# ZU1 SYSTEM BLOCK DIAGRAM

**PROJECT : ZU1**  
**Quanta Computer Inc.**

|   | <b>Block Diagram</b> | 3B  |
| Date: Tuesday, April 10, 2007 Sheet 1 of 39 |                      |     |

|       | <b>CLK_GEN/CK505</b>    | <b>3B</b>     |

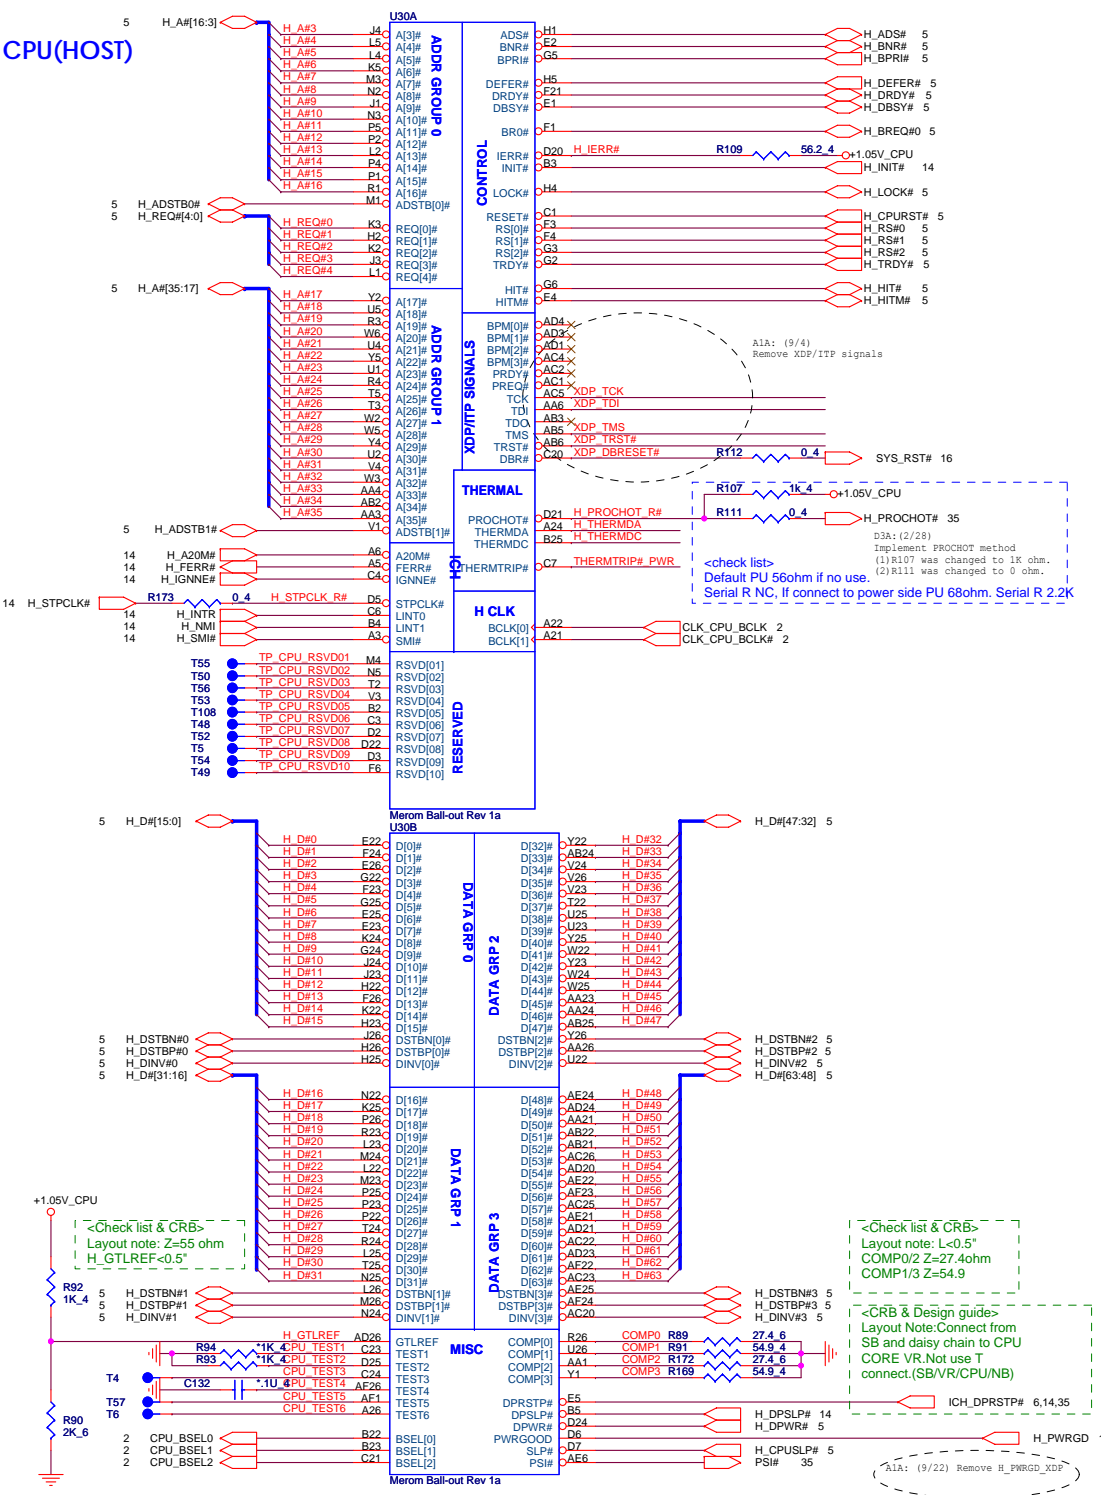
A1A: (9/24) Base on above table, SWAP SRC3 and SRC9

A1A: (9/24) Add PCIE\_CLKREQ# PU to +3V

C2A: (12/12) change from +1.05V to +1.25V. Because VDD\_IO will drop out when high loading

C2A: (12/10) no stuff R179, R198, R447 for auto CPU frequency selection (follow ZD1, Z01)

| Size  | Document Number<br><b>GMCH HOST(1 of 7)</b> | Rev<br><b>3B</b> |

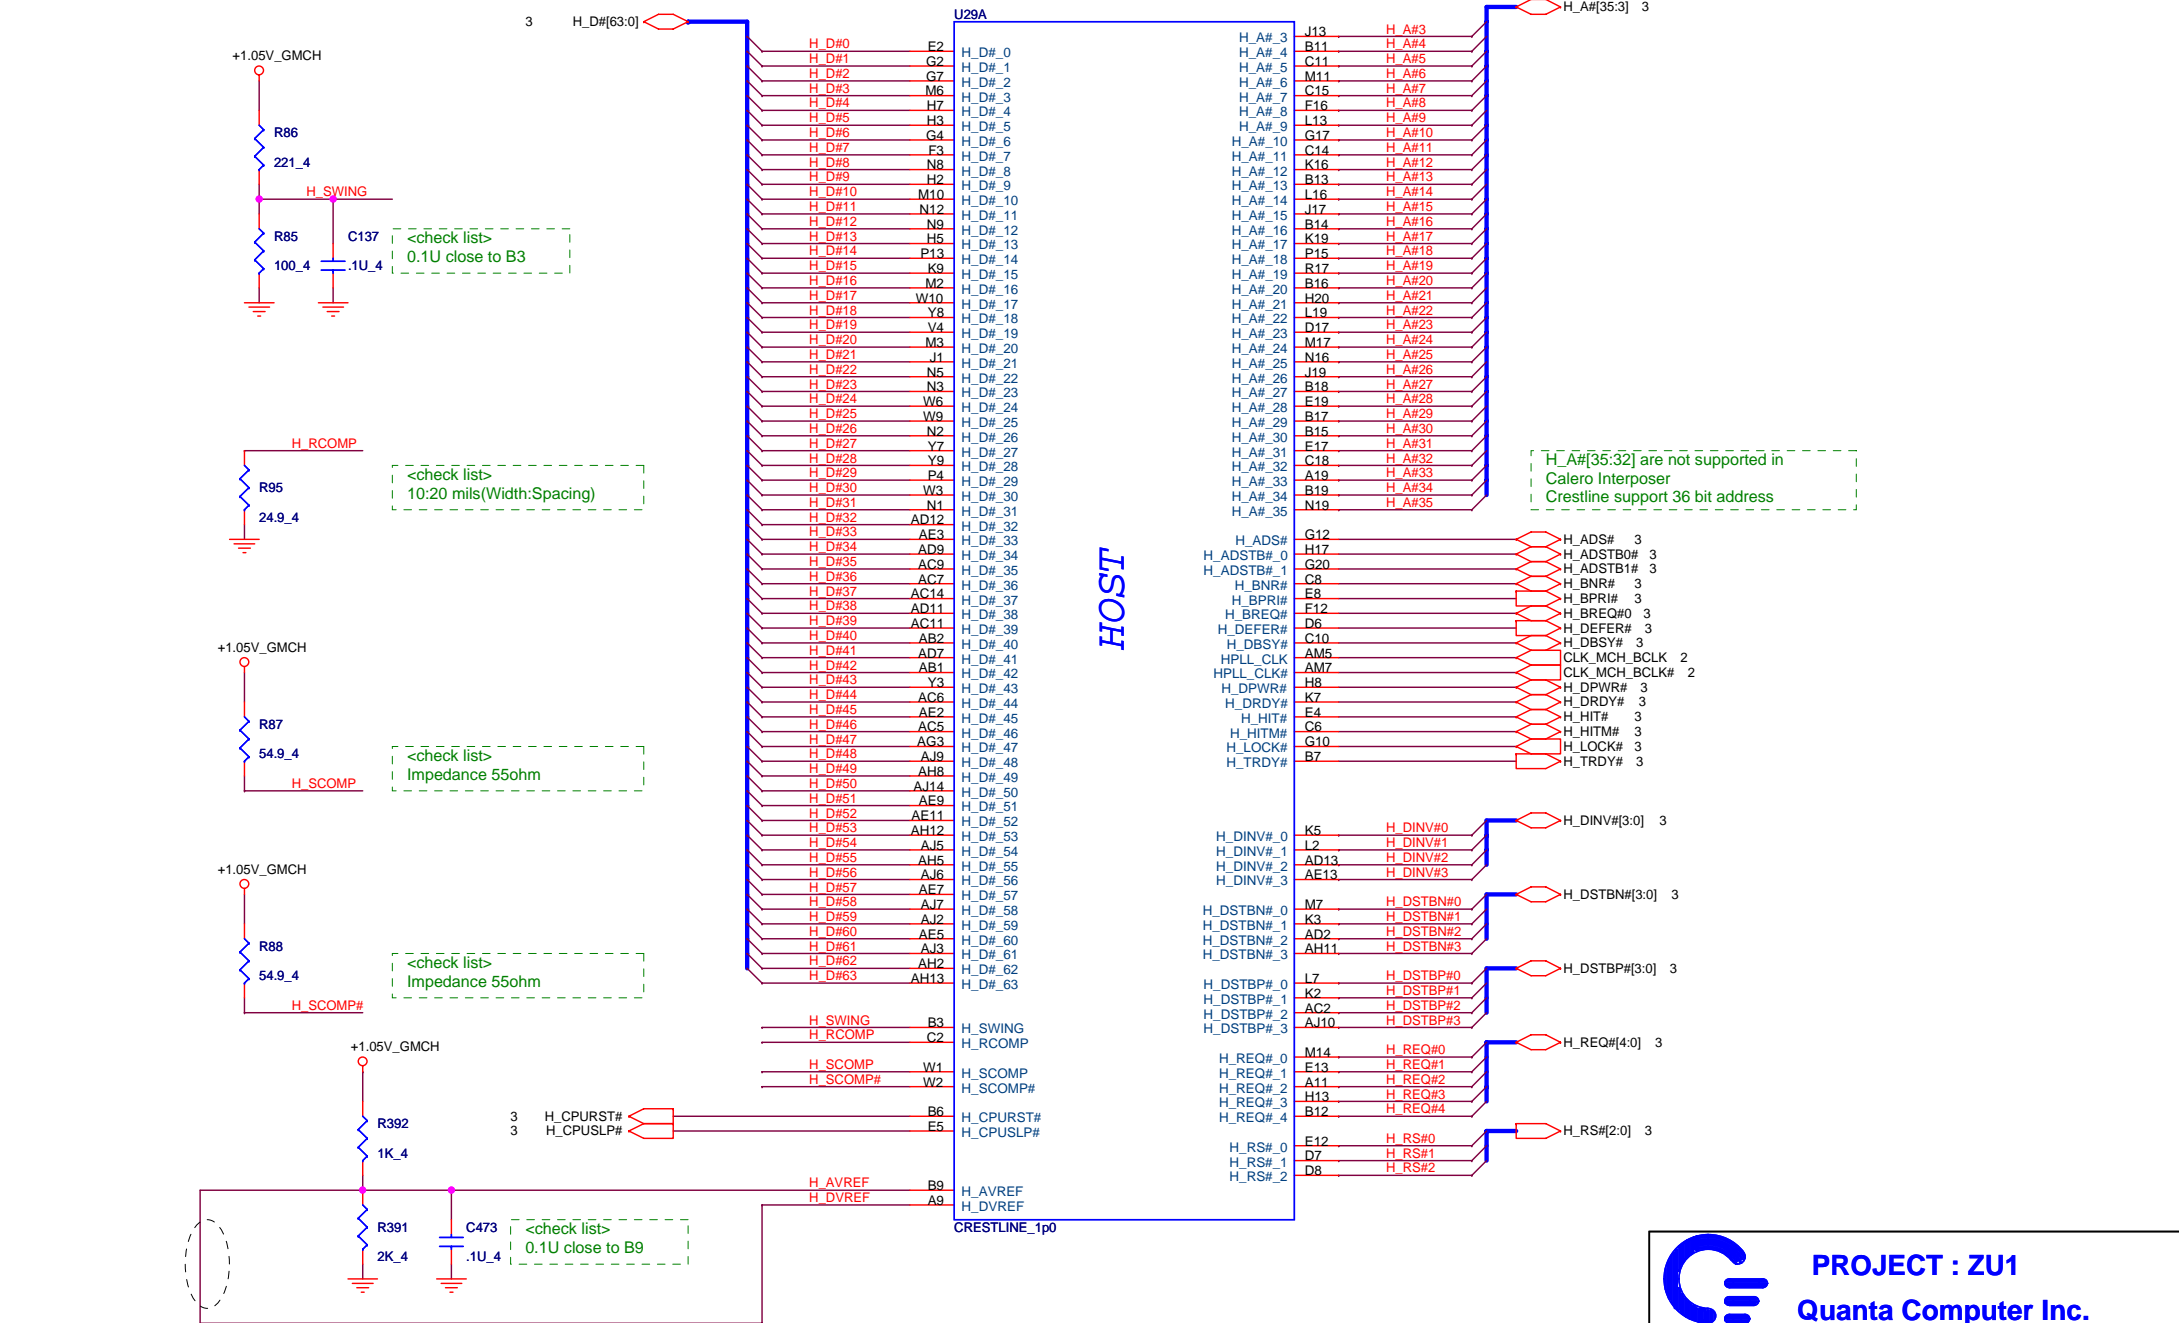
A1A: (9/20) remove R74 (0 ohm)

|   |                         |       | <b>GMCH Power-3(6 of 7)</b> | <b>3B</b> |

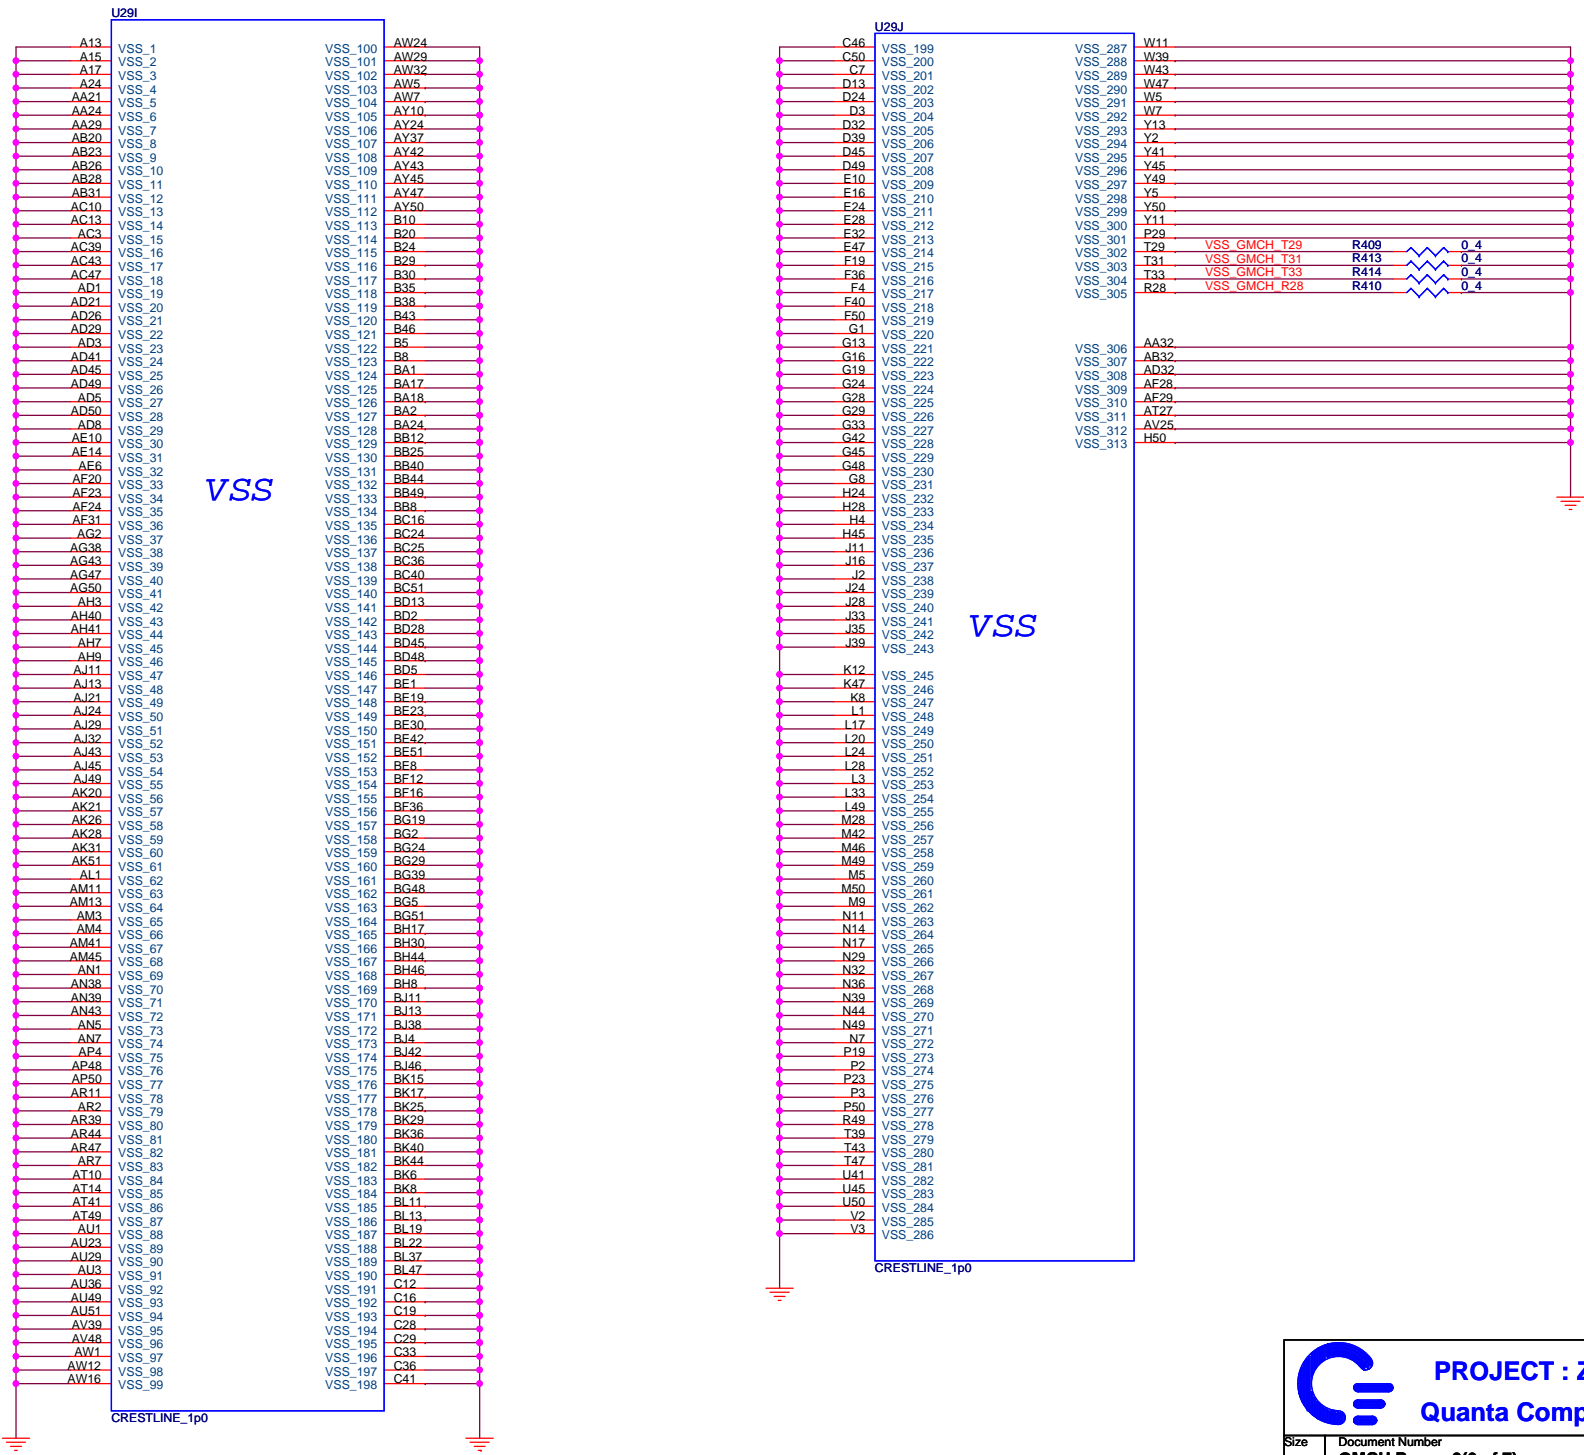
C2A: (12/12) Change Crestline VCC\_AXM to 1.25V, reference to SR ww48 MoM, reserved 0 ohm resistor (R576)

C2A: (12/12) Change Crestline VCC\_AXM from +1.25V to +1.05V, reserved 0 ohm resistor (R578)

|       | <b>DDR RES. ARRAY</b>   | 3B             |

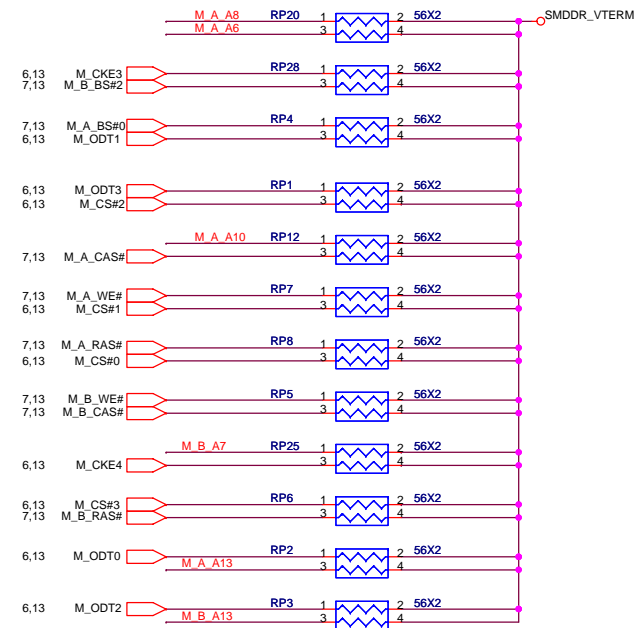
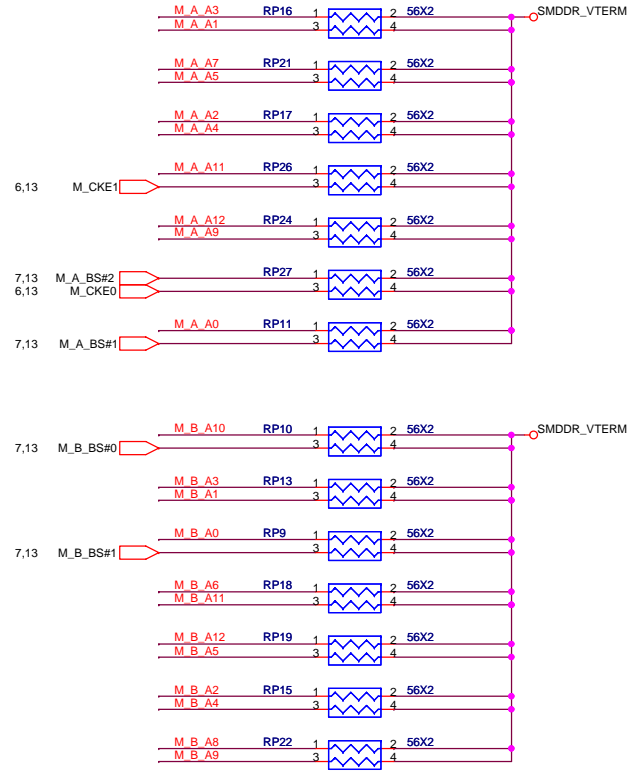
INTEL FAE (08/17)  
 ADD MA14 FOR DUAL LAYERS RAM

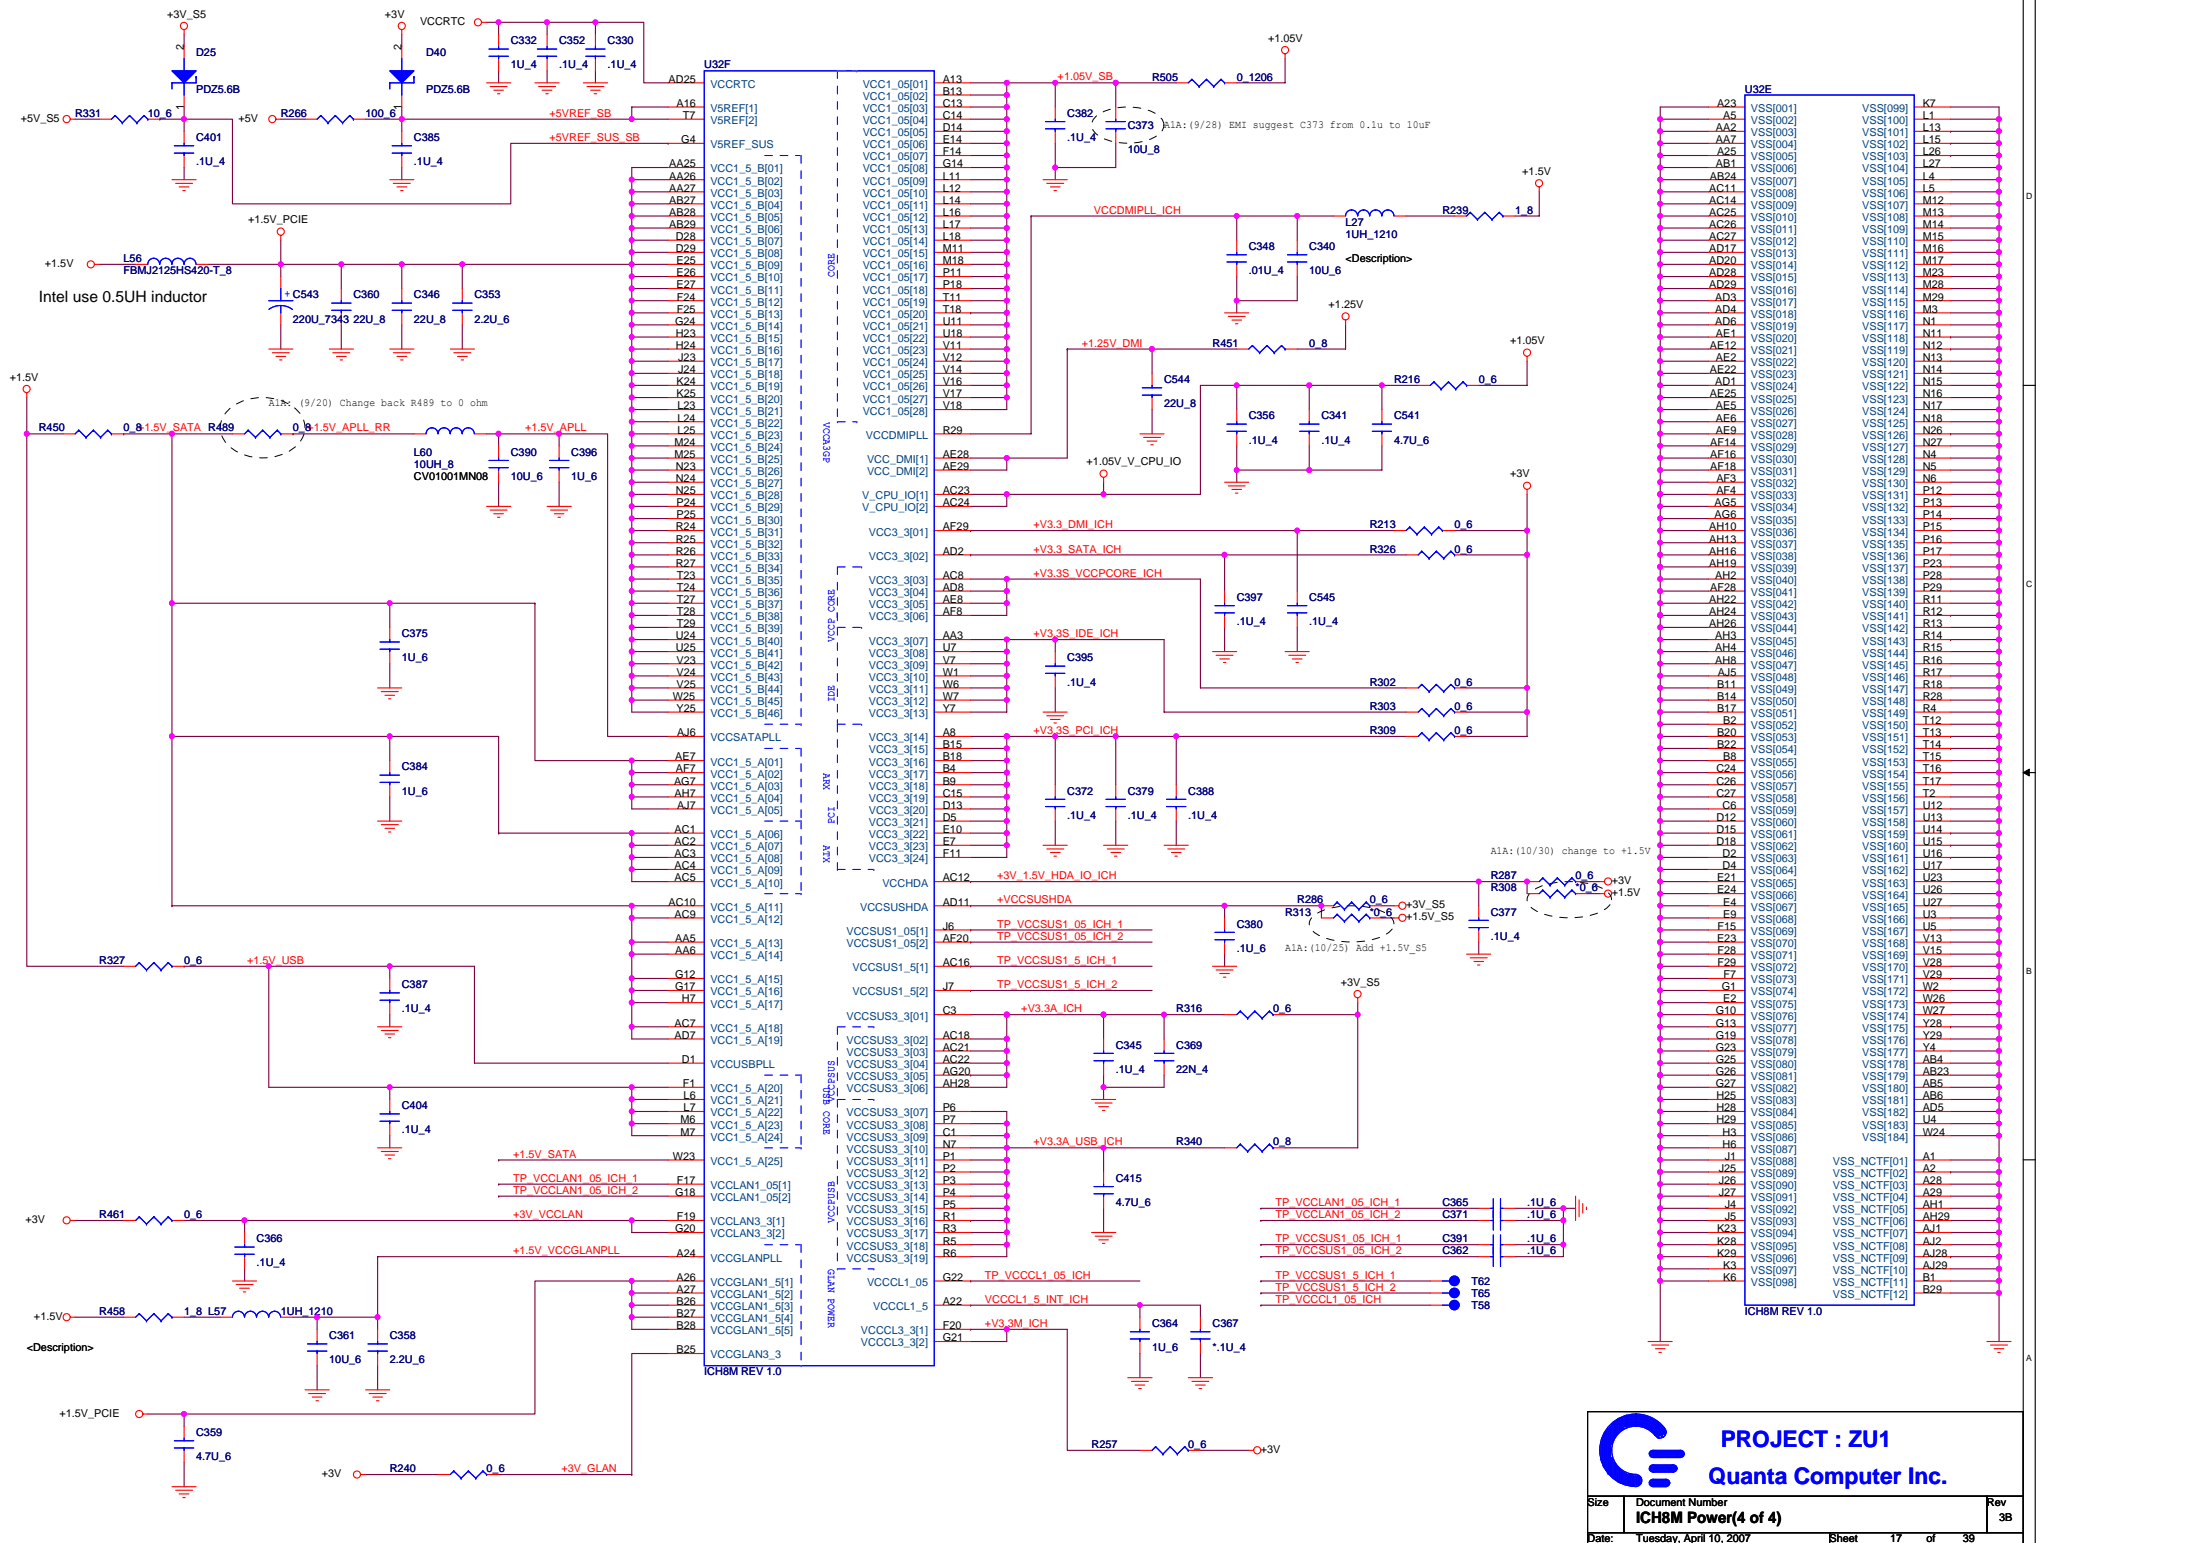
D3A: (1/31) ASP issue: when iAMT is not implemented, ICH8M SMBUS and SMLINK should be connected together to support slave mode. Connect SMLINK0 to SMBCLK and SMLINK1 to SMBDATA (Add R474, R475 for debug use).  
 A1A: (9/29) no support iAMT, remove SMB\_CLK\_ME, SMB\_DATA\_ME

C2A: (12/12) Intel Suggest : ICH8M GPIO20 should not be pulled HIGH. Remove BOARD\_ID3 circuit (remove R474, R475)
